Quality Control Check Report. Stage: After Finishing Stage III (Villas)

Villa No	27	Other	Sl. No.	37465
Company	Serene Construction	Project	Phase	-
Prepared by	T. Vinod Kumar	Sign	Date	09-04-21
Project Manager	Sarwaal	Sign	Date	09-04-21
Previous stage report no.	36812		Report filed and signed by PM	☒ Yes ☐ No
Checked By MD on		MD Sign	For filling	☐ Yes ☐ No

Farmhouse No	27	Building type	Villa/cottage
Buyer Name	S. Raja Ram Sudhakar		
Phone No.	9848426481	Email	Sudhakar-Srr@yahoo.co

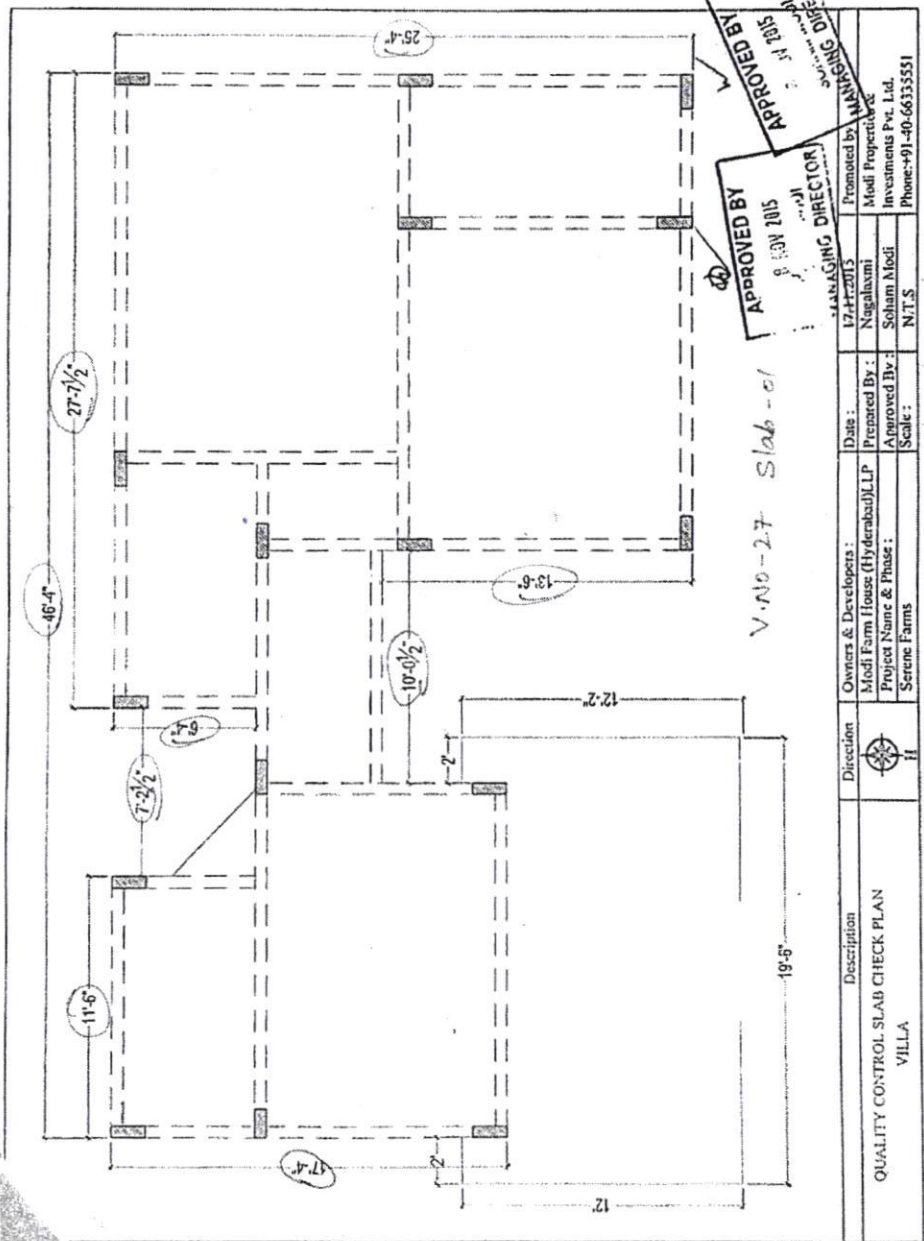
Note:- shuttering levelling to be improve, as previously also mentioned.

Confirmed that all corrections mentioned in the QC report have been completed. Work can proceed to next stage.
